Technical Advisory Bulletin (TAB)

Bulletin #: TBBE1611A

Product: BERNINA E16

Subject: New Control Board

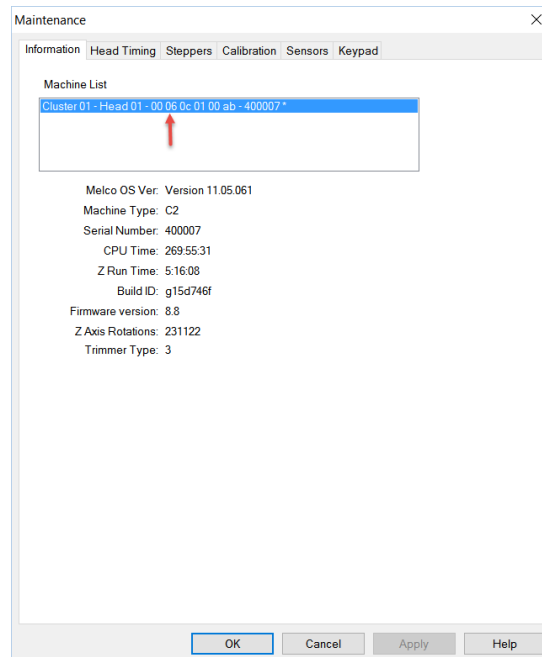
Calibration window for TBS has been hidden. This has been done due to the fact that factory calibration should be solid enough for the majority of the users.

To expose TBS calibration:

1. Computer\HKEY_CURRENT-USER\SOFTWARE\BERNINA\MC\Settings
 2. Create a new DWORD (32-bit) Value
 3. Name = ShowTBS
 4. Value 1 = on
 5. Value 0 = off
- 5) **Homing Frame:** New Control Board homes both X and Y axes at the same time.
 - 6) **Trimming:** New Control Board has a slightly different behavior during the trim sequence. This is mainly due to the way all motors work with the new Control Board and how the new firmware processes all the steps involved. The difference is mostly in how quiet/smooth the grabber moves in and out.
 - 7) When exiting the timing window in **maintenance mode** the machine no longer beeps. There has been user feedback that this was not needed.
 - 8) In **Maintenance** pressing speed  + Left  will take the Z-Axis to 120° which is just above the Needle Plate hole. This is a good placement for Needle Plate adjustment.
